Addendum No. 2

Subject: W.B. Saul High School – New Livestock Center
SDP Contract Nos. B-011C, B-012C, B-013C of 2017/18

This Addendum, dated 25th of April, 2018, shall modify and become part of the Contract Documents for the work of this project. Any items not mentioned herein, or affected by, shall be performed strictly in accordance with the original documents.

PANEL SCHEDULE 02

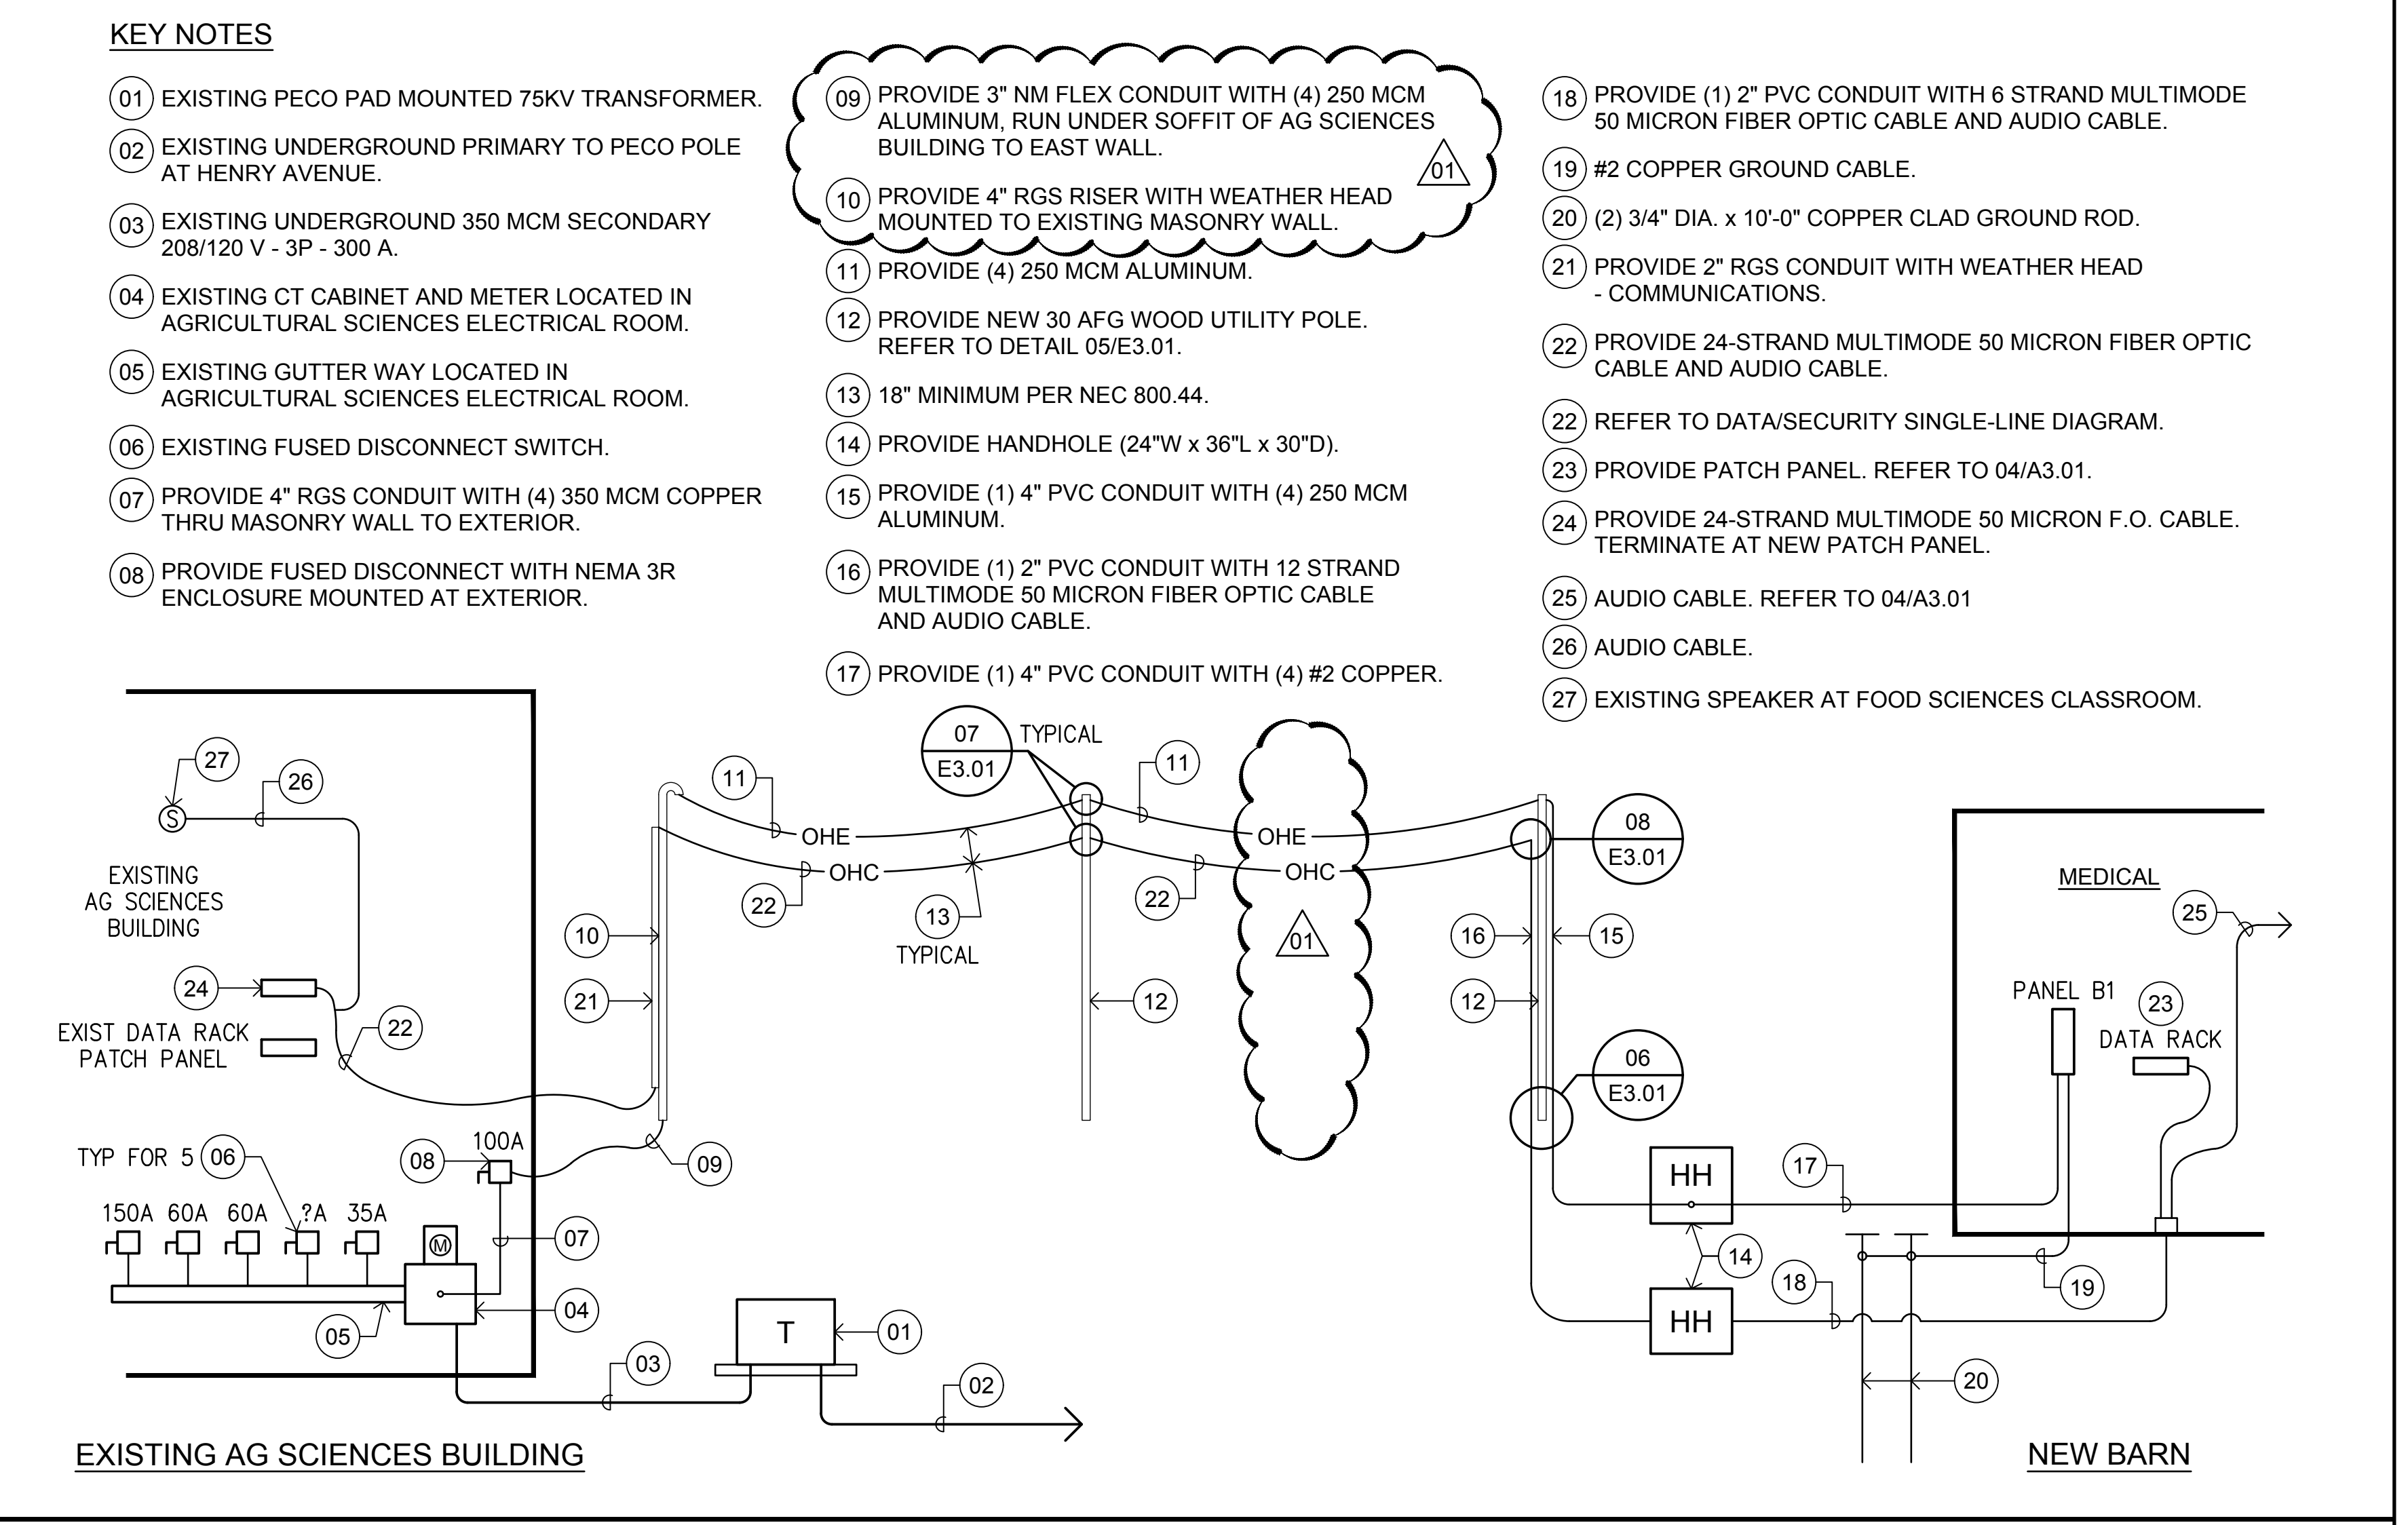
10. Water heater - I noticed that the electrical panel schedule on E3.01 listed the device as a 50 amp 208v single phase load. The water heater schedule on P3.01 lists the water heater as a 40 amp 208v three phase load. Looking up the Temptra 36 by Stiebel Eltron I find that this water heater is neither of the above but a device that requires three 50 amp 208v single phase circuits. This means that there needs to be two more 50a/2p circuit breakers in panel B-1. Should we just price as is for now?

- a. Revised Keynote No. 9 to read "Provide 3-inch NM flex conduit with (4) 250MCM aluminum, run underneath soffit of existing Ag Sciences Building to the east end of the building."
- b. Revised Keynote No. 10 to read "Provide 4-inch RGS riser with weather head mounted to existing masonry wall on the east end of the Ag Sciences Building."
- c. At Detail 02 Panel Schedule, revised Circuit 7/9 to 40A/2P and wire size to No. 8 AWG.

Response: See changes to drawings for water heater revision.
